December 2022 Changes to Proposed Development at 109 Palmerston St Perth

SUMMARY

Figure 4. Overshadowing of 107 Palmerston St. caused by the Fig tree in Robertson Park June 3, 2022.

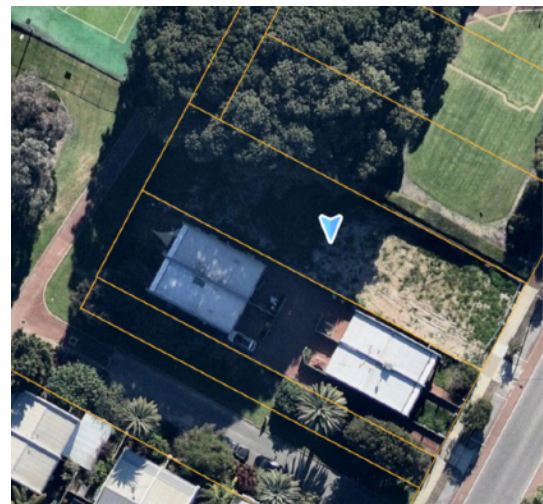
e) Clause 5.4.2 of the R Codes in relation to Solar Access for Adjoining Sites. The development has not been appropriately designed to protect the neighbouring property's (No. 107 Palmerston Street) access to direct sunlight to outdoor living areas and major openings, and would adversely affect the amenity of the neighbouring property;

- The site is heavily overshadowed from the North by the neighbouring fig tree, therefore solar access from the North is not possible for the rear neighbouring homes or the courtyard between the homes. Figure 4 shows the overshadowing caused by the tree taken on June 3, 2022.

- All the North facing windows on the rear neighbouring unit are overshadowed by the Fig tree in Robertson Park (Figure 4). Our development will not cast any additional overshadowing on the rear unit.

- The neighbouring properties are setback only 1m from their North boundary. This proximity means that their North facing walls will be shaded regardless of our overshadowing percentage. Overshadowing of 20% or 60% will have the same shading effect on the North facing walls, therefore meeting the deemed to comply value of 50% would not achieve the desired outcome of the Design Principles.

Figure 5. Location of neighbouring property windows in relation to the proposed development. The yellow circle shows the only major opening with existing North facing solar access.

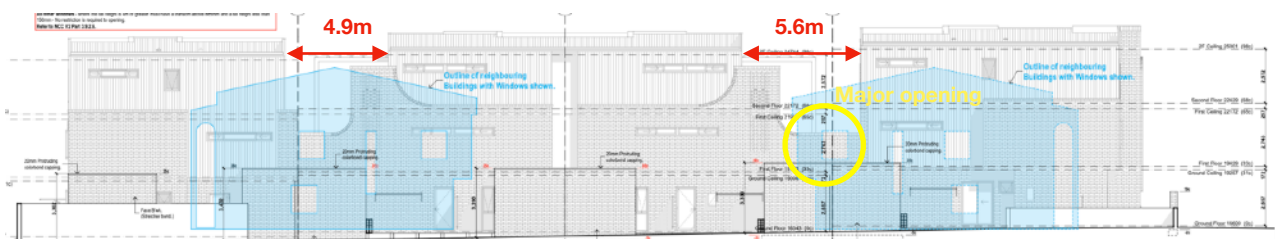
b) Clause 5.1.3 of the R Codes in relation to Lot Boundary Setbacks. The proposed development would adversely affect the amenity of the neighbouring property at No. 107 Palmerston Street because it would not maintain adequate access to direct sun into buildings and open spaces, and the proposed development has not been appropriately set back from the south western lot boundary nor designed to reduce the impacts of building bulk and scale;

- Our proposal has maintained the flow of air and dappled light to the neighbouring properties by providing meaningful spacing between the units. These have been aligned with the windows of the neighbouring property, to decrease the impact of bulk and scale (Figure 5). Hit and miss brickwork feature walls to parts of this area provide visual interest and privacy.

- The front RHS unit has one major opening facing North. (The other large window on the North is located on the staircase landing and is therefore not a major opening). We have preserved North facing solar access to the major opening of the front unit with a 5.6m wide gap between our units which is aligned with the window in question (Figure 5.) This room also has an additional window facing North West so it will have ample solar access during various times of the day.
